The F_Q SURVEILLANCE TECHNICAL SPECIFICATION
(Part B of NS-EPR-2649)

R. W. Miller
N. A. Pogorzelski
J. A. Vestovich

TECHNICAL SPECIFICATION CHANGES

A.1	MODIFICATIONS TO 3/4.2.2 HEAT FLUX HOT CHANNEL FACTOR LIMITS	B-8
A.2	ADDITIONS TO 6.0 ADMINISTRATIVE CONTROLS	B-17
A.3	SAMPLE PEAKING FACTOR LIMIT REPORT	B-19

FIGURE 1
TYPICAL WESTINGHOUSE RELOAD CORE
RAOC W(Z)

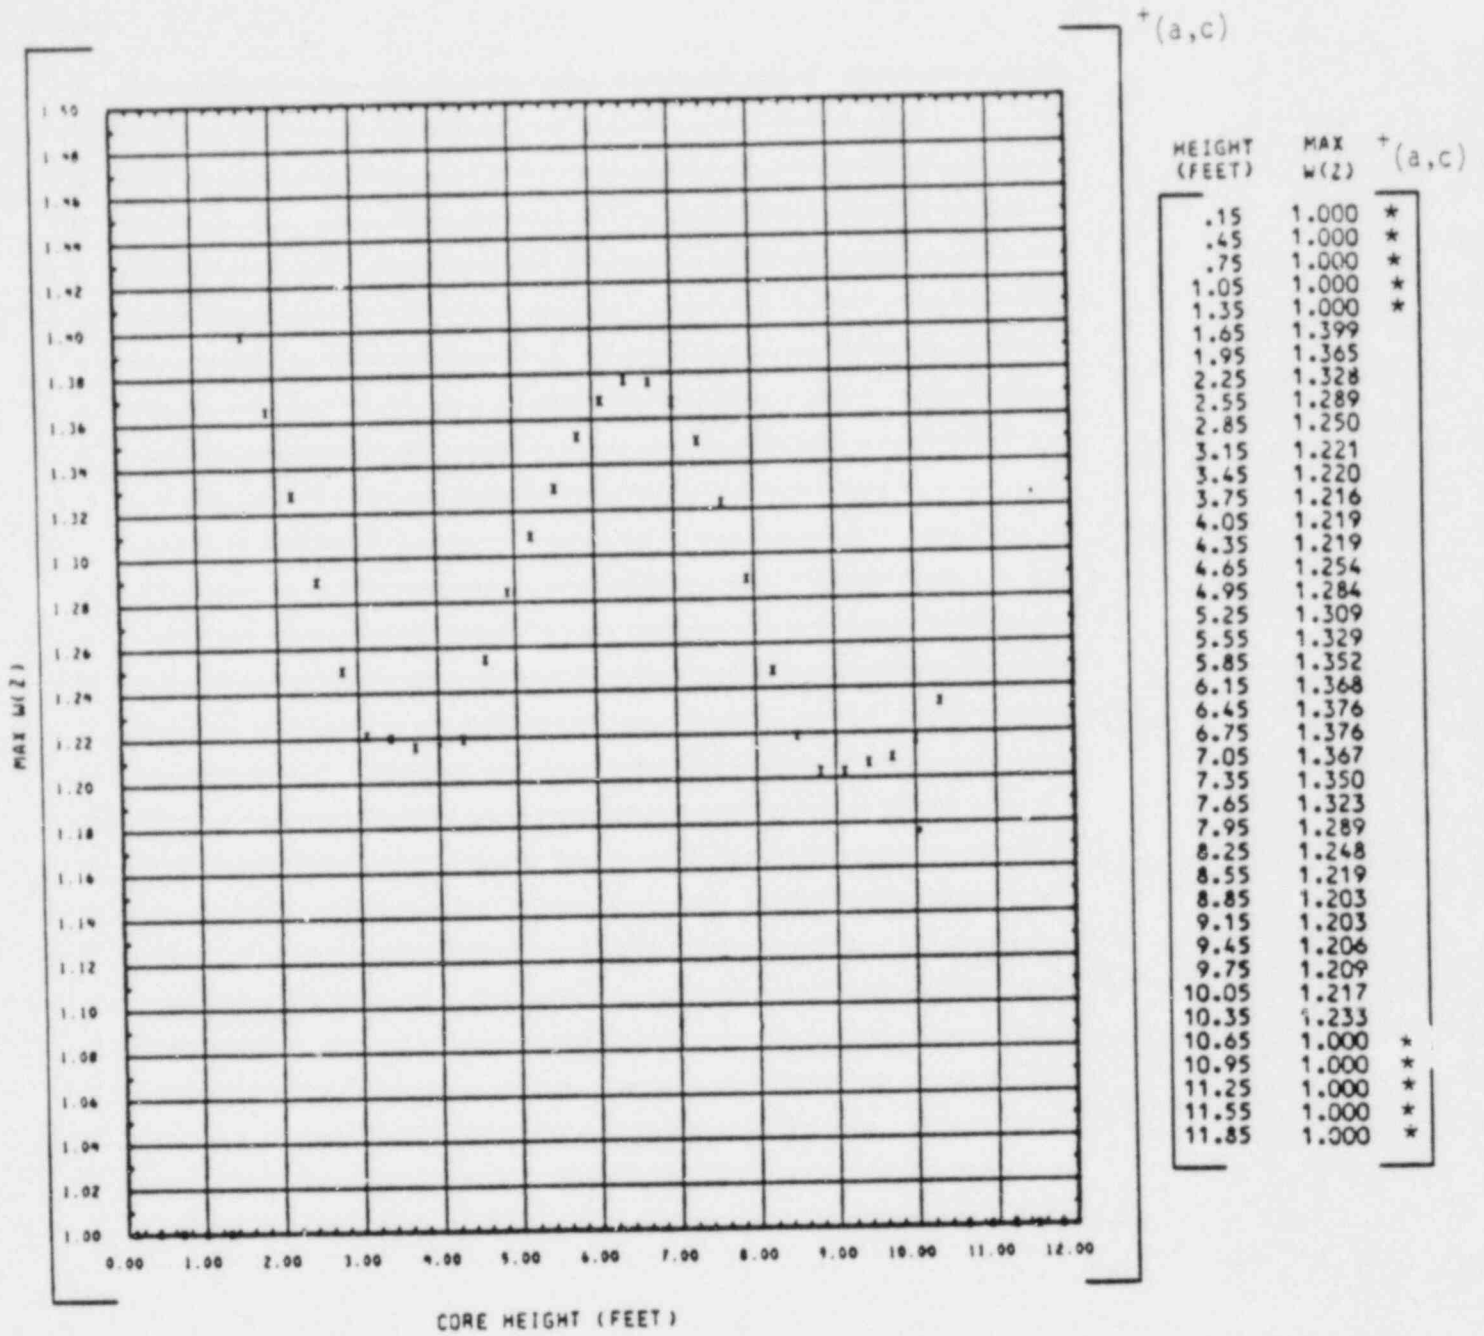
The Cycle N $W(z)$ function for RAOC operation is shown in Figure 1. $W(z)$ was calculated using the method described in Reference 1.

* Top and bottom 15% excluded as per
Technical Specification 4.2.2.2.g
